ADDENDUM NO. 1

RE: **NCDOT Highway Division 1 – Camden County Rest Area, U.S. Highway 17,
Camden County, NC
SCO ID No. 14-11342-01A**

PREPARED BY: Facilities Design, NCDOT

11 ELEVATION
 A2.2 SCALE: 1/4" = 1'-0"

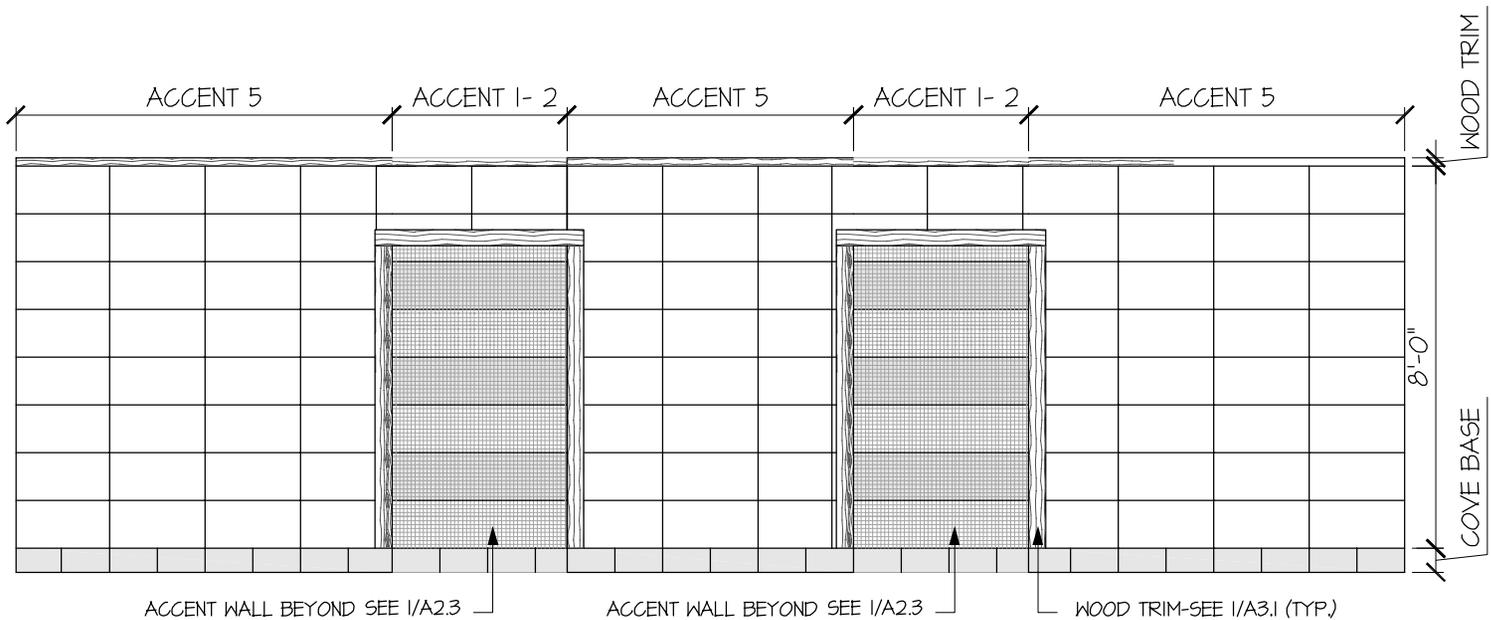
<u>Item</u>	<u>Sheet No.</u>	<u>Description:</u>
1.	A2.2	See attached Bulletin Drawing AB1, for clarification of wood trim around entrances to restrooms, Elevations 11/A2.2 & 12/A2.2.
2.	A1.0	Clarification of Demolition Key Notes D-10 and D-11 which overlap on . . . Sheet A1.0: "D-10: In Men 106 & Women 107, Contractor to remove tile and wall sheathing on South and West walls when Architect is present on site. Minimum one week notification of date of demolition to be given. The existing tile has a horizontal stress fracture along the entire wall and the stress fracture must be evaluated."
